P 27316
A 18306

SEWAGE DISPOSAL SYSTEM
MARYLAND STATE DEPARTMENT OF HEALTH

SUBDIVISION Eagles Loft ROAD Huntsmans Run LOT 17

PERMIT CARD Holcom 12/20/77 Huntsmans Run 51T D. W.
 SEPTIC TANK, LEVEL OK CLEANOUTS ✓
 DISTRIBUTION BOX, LEVEL N/A

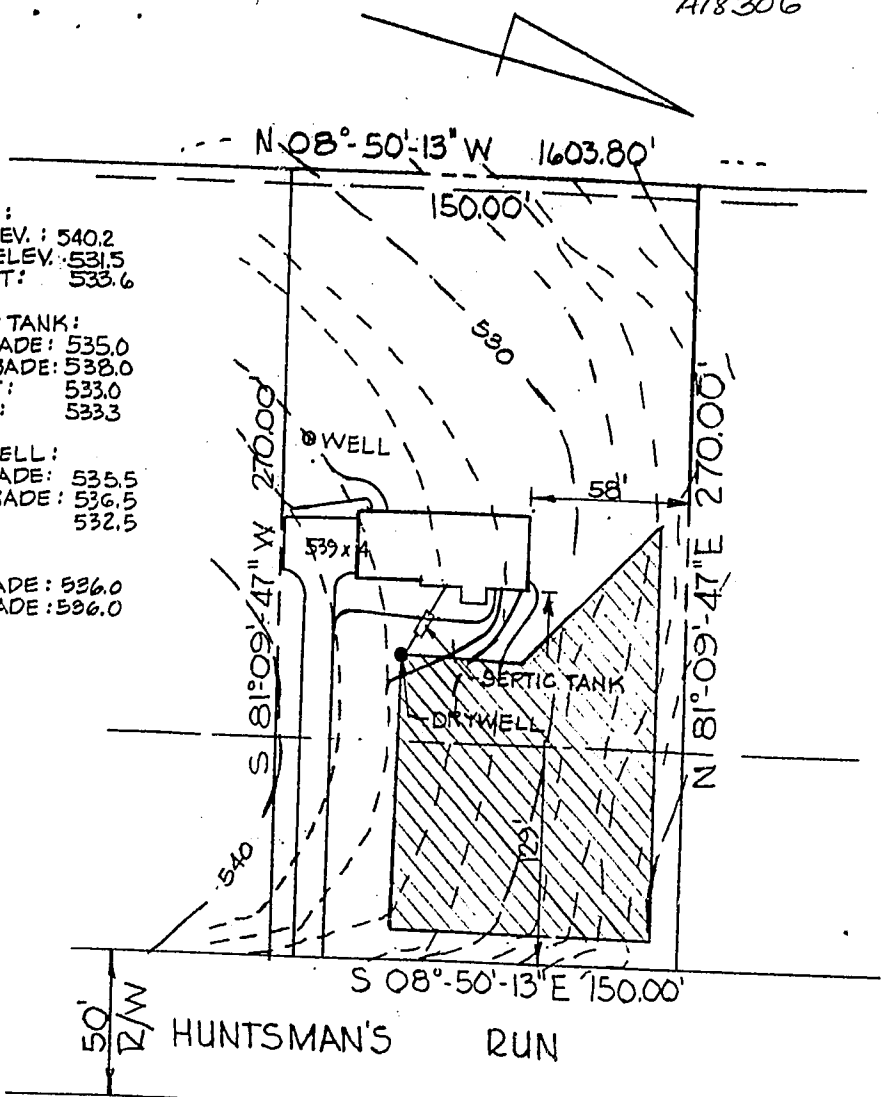
REMARKS 12/23/77 - TANK & DW NOT INSTALLED DITCH DUG
NOT FILLED. ADD STONE TO DITCH. INSTALL TANK & DW
IF SEWER LINES & CALL FOR INSPECTION R.H. CMB
12/29/77 partial waiting for gravel in Drywell and Trench. Need
5ft more + rep. should be 33 ft. OKAY to Back fill from house to 2 ft. of Drywell.
Call for re inspection, left info. with owner. M.B. 12/27/77 re inspection CMB
12/30/77 Finished per above. C. B. Bunker
 DATE SYSTEM APPROVED 12/30/77 INSPECTOR _____
